### Tremolo modification notes

# Ampeg J-12B Jet

Original J-12-B circuit

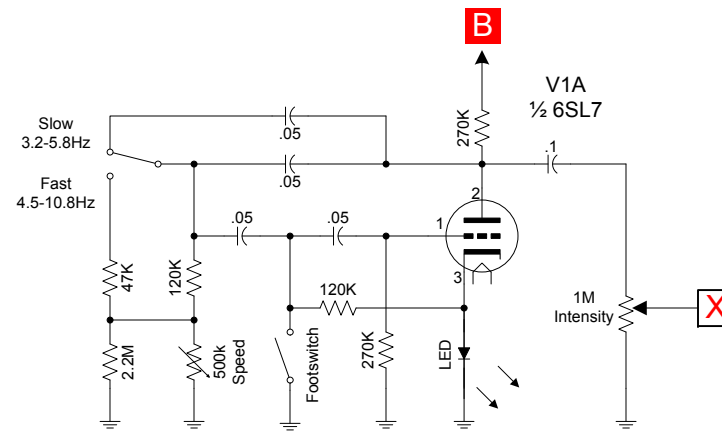
- Replaced V1A cathode R/C with yellow LED for more trem signal.
- Moved Speed control to first R/C phase shift node.
- Added Speed switch for greater speed range.
- Replaced tremolo output 1M resistor with 1M Intensity pot.
- Tremolo footswitch rewired same as Fender 6G16 to allow fast start with no pops.
